POWER GRID COMPANY OF BANGLADESH LIMITED
BIDDING DOCUMENT
FOR
Plant Design, Supply and Installation of Package - 2 (TL-2)
400kV Madunaghat - Matarbari Double Circuit Transmission Line on Turnkey Basis
(Bid Identification No.: 27.21.0000.101.07.217.18.2354), (Reference Identification No.: PGCB/ MUSCCFPP /Package-2/TL-02)

Clarifications No. 1
Project: 400kV Madunaghat - Matarbari Double Circuit Transmission Line

[A pre-bid meeting was held on 26th April, 2018. Clarifications to the queries received from the prospective bidders regarding the bidding document prior to, during the pre-bid meeting & after the pre-bid meeting and associated Addendum No.1s are given below which will form part of bidding document.]

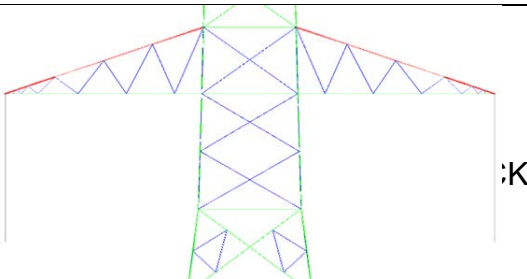
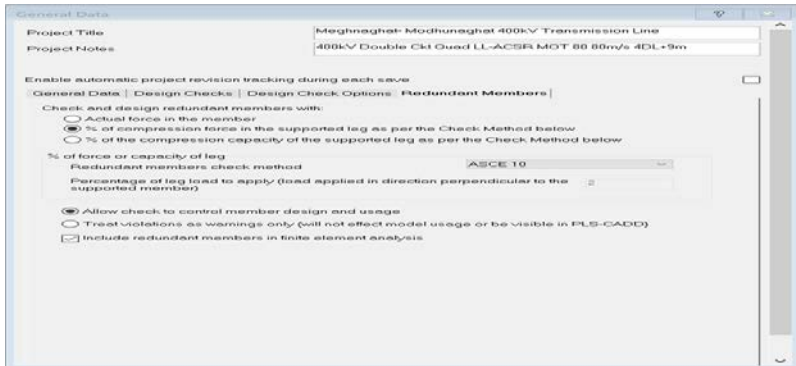
19	Vol 2 Sec.8 Tower	Can we use neck before waist level as per the picture below-	Bend point (change in slope) must be within the suspension string length for suspension tower and within the length of jumper sag for tension tower.

Bend point shall be only one which may be below / at bottom cross arm level.															
20	Vol.2 Sec.11 Conductors Annex- 11-3 Portion Conductor System Loading P11-18	<p>Page 11-18 Vol-2 of the Bidding Document</p>
